## Determination 2011/045

# The durability of support brackets installed in the concrete floor slab to an aircraft hangar at 1627 Manapouri-Te Anau Highway, Southland

**Figure 1**

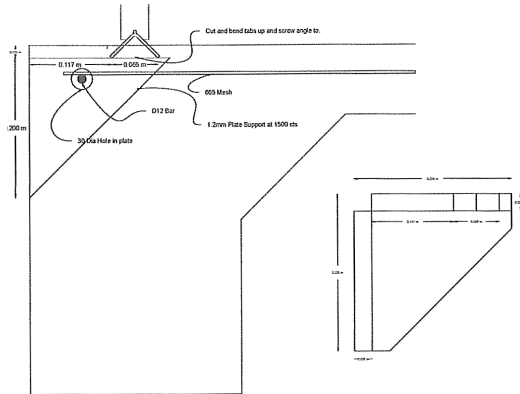
the door have not been provided to me, but the design included the provision of a metal angle (“the door track”), which I assess as nominally 40mm x 40mm in dimension, being cast into the floor directly under the door as shown in Figure 1. This provides a triangular cross section above the floor slab to serve as a guide or support for door runners.

- Foundation beam compromised by the 200mm x 200mm brackets and will not resist tensile pull.
  - The 12mm diameter rod not adequately protected from moisture, due to the moisture track from the side of the foundation beam provided by the brackets.

- The 30mm diameter hole in the bracket provided poor protection for the reinforcing rod.
  - The reduction in the cross section of the beam due to the brackets.

1. That the structural integrity of the foundation beam had been compromised by culling into the effective cross sectional area of the designed beam and restricting the tensile effectiveness of the [reinforcing] in the top outer edge. [The reinforcing] has very little concrete around its perimeter with the bracket intersecting the beam eight times in the opening length of the door.
- 2 The Building clause ... requires that structural elements require a 50 year durability.... To give a satisfactory durability with reinforcement, a 50mm cover is required from steel reinforcement to the outer edge of the foundation wall.

With a detail like the bracket installation, there is a clear moisture track created down the side of the brackets to the reinforcement leaving only 9mm of protective cover with the concrete, 41mm short of the Code requirement.

While [the authority] acknowledges that the Engineer has taken responsibility for the structure, it is not satisfied with the epoxy resin cover as a durability precaution. Epoxy substances are generally a non-flexible material and will not allow for the expansion and contraction expected of a beam of this nature. Also the 30mm cover requirement above the slab is well outside the weather line where it meets the bracket and creates a weak section where no protection is provided. Cracking is very likely in this area.

It should be noted the brackets are flush with the outside building line and only 30mm below the surface of the floor which is outside the weather line. There are two moisture tracks created, one where the [door track] meets the concrete on the outer edge and the exposed surface on the foundation wall.

5.1 In accordance with section 188 of the Act, I hereby determine that the authority did not have reasonable grounds to consider the building work would comply with Building Code Clause B2 Durability at the time the notice to fix was issued; and accordingly I confirm the authority's decision to issue the notice to fix.

5.2 In accordance with section 188 of the Act, I also determine that there are now reasonable grounds to consider the building work does comply with Clause B2 Durability of the Building Code, and accordingly I reverse the authority's decision to refuse to issue a code compliance certificate.
